Southern Nuclear Operating Company
Vogtle Electric Generating Plant Units 3 and 4
Request for License Amendment and Exemption:
Tier 1 Editorial and Consistency Changes (LAR-13-017)

**Request for License Amendment
Regarding
Tier 1 Editorial and Consistency Changes
(LAR-13-017)**

**Exemption Request
Regarding
Tier 1 Editorial and Consistency Changes
(LAR-13-017)**

**Insertions Denoted by Blue Underline and Deletions by Red Strikethrough
Figure Changes Contained to Red Bubbled Area**

Change (a) - Tag Number Updates
Tier 1 Figure 2.2.5-1
[VEGP Tier 1, pg 2.2.5-16]
[VEGP Unit 3 COL, Appendix C, pg C-181]
[VEGP Unit 4 COL, Appendix C, pg C-181]

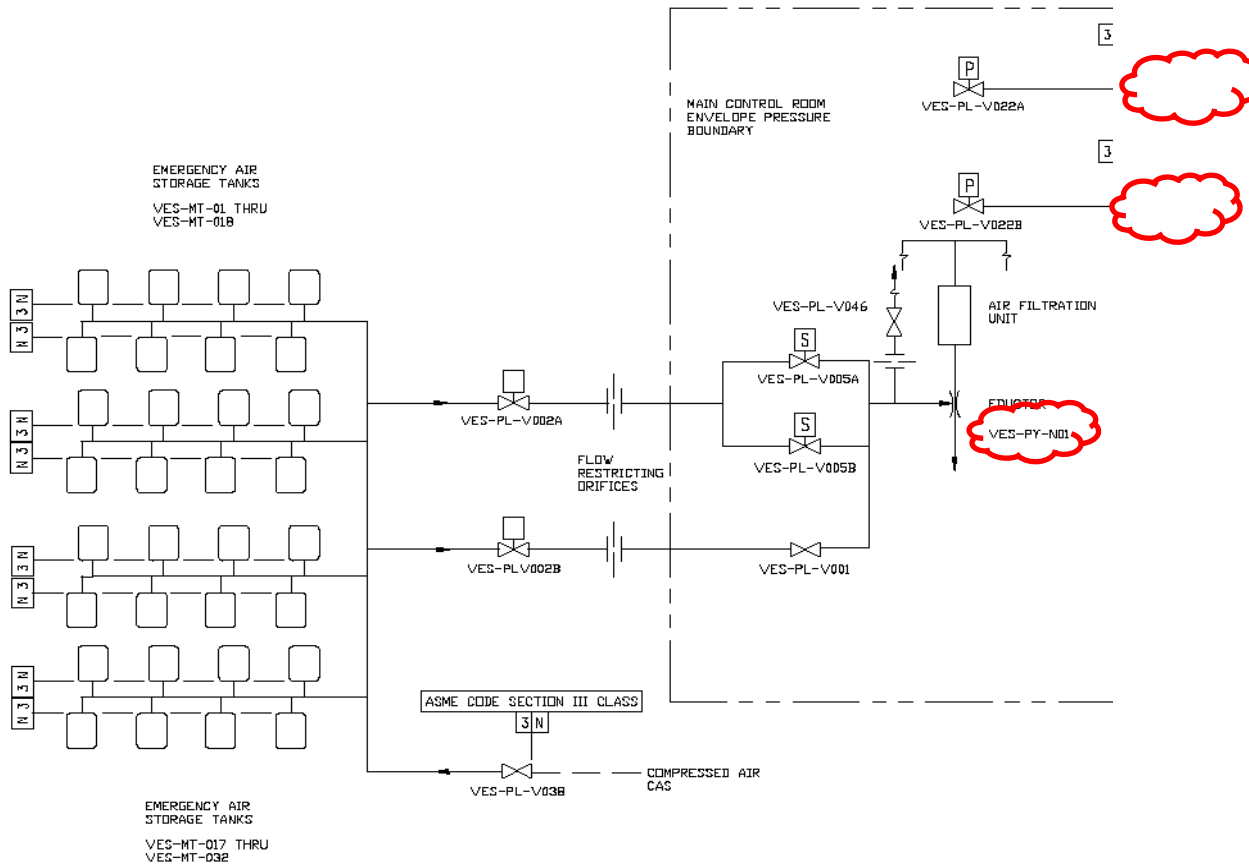
UFSAR Table 3.2-3 correctly identifies the Main Control Room (MCR) Emergency Habitability System (VES) Relief Dampers tag numbers as VES-MD-D001A and –D001B, and the tag number for the MCR Air Filtration Line Eductor as VES-PY-N01. In contrast, plant-specific Tier 1 Figure 2.2.5-1 incorrectly identifies the dampers’ tag numbers as VES-PY-D001A and D001B, and the eductor’s tag number as VES-FY-N01. To resolve these inconsistencies, changes are proposed to update the tag numbers identified in Tier 1 Figure 2.2.5-1 from “VES-PY-D001A” to “VES-MD-D001A,” from “VES-PY-D001B” to “VES-MD-D001B,” and from “VES-FY-N01” to “VES-PY-N01.”

- Tier 1 Figure 2.2.5-1
 - Change Main Control Room (MCR) Emergency Habitability System (VES) relief damper tag numbers from VES-PY-D001A to VES-MD-D001A and from VES-PY-D001B to VES-MD-D001B.

- Change the MCR Air Filtration Line Eductor tag number from VES-FY-N01 to VES-PY-N01.
- Tier 1 Table 2.6.3-4
 - Change distribution panel tag number from IDSC-DD-2 to IDSC-DD-1.
